SOLICITATION AMENDMENT

This amendment 002 is raised to answer questions from potential bidders that came up during the site visit. See herein.

Title - Sujet Air Compressor	
Solicitation No. - N° de l'invitation 39903-170564/A	Amendment No. - N° modif. 002
Client Reference No. - N° de référence du client 39903-17-0564	Date 2016-11-08
GETS Reference No. - N° de référence de SEAG PW-\$HAL-220-9942	
File No. - N° de dossier HAL-6-77119 (220)	CCC No./N° CCC - FMS No./N° VME
Solicitation Closes - L'invitation prend fin at - à 02:00 PM on - le 2016-11-18	
Time Zone Fuseau horaire Atlantic Daylight Saving Time ADT	
F.O.B. - F.A.B. Plant-Usine: <input type="checkbox"/> Destination: <input checked="" type="checkbox"/> Other-Autre: <input type="checkbox"/>	
Address Enquiries to: - Adresser toutes questions à: Dunphy, Nancy	Buyer Id - Id de l'acheteur hal220
Telephone No. - N° de téléphone (902) 496-5481 ()	FAX No. - N° de FAX (902) 496-5016
Destination - of Goods, Services, and Construction: Destination - des biens, services et construction:

This amendment 002 is being raised to answer questions that came up at the site visit from potential bidders as follows:

Drawing # 1

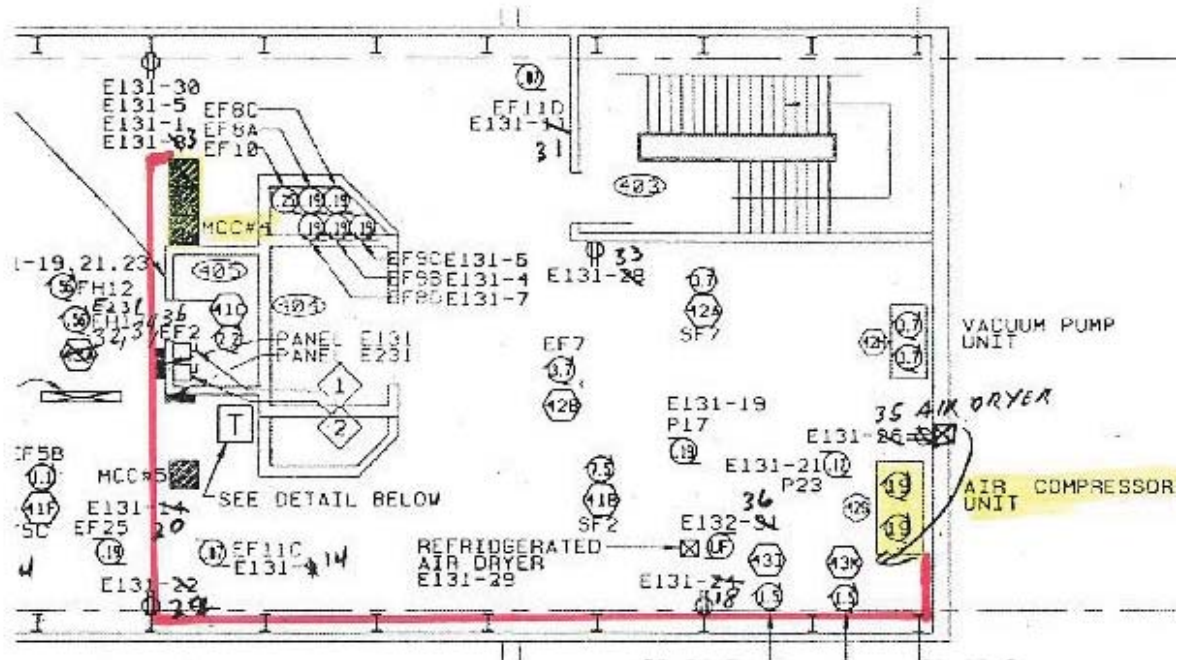
Question 4. The length of the wires that presently feed the 2 transformers is not long enough for the new disconnect switches that take the place of the transformers.

- The wire feeding transformer # 2 is sufficient in length and can be reused for bottom entry disconnect switch #2. Adjust height of disconnect switch to match length of cable.
- The wire feeding transformer # 1 is too short (photograph "B"). Remove and replace Teck cable piece of electrical feed for transformer #1 and replace with new EMT conduit from junction box under slab (photo "C") to new disconnect switch #1 following original route of original Teck cable. Use old junction box under slab as a pull box with no splices. Approximate length of wire required is _88 feet_ from MCC#4 to new disconnect switch #1 (drawing #1). Firestop floor penetration where EMT passes through slab.
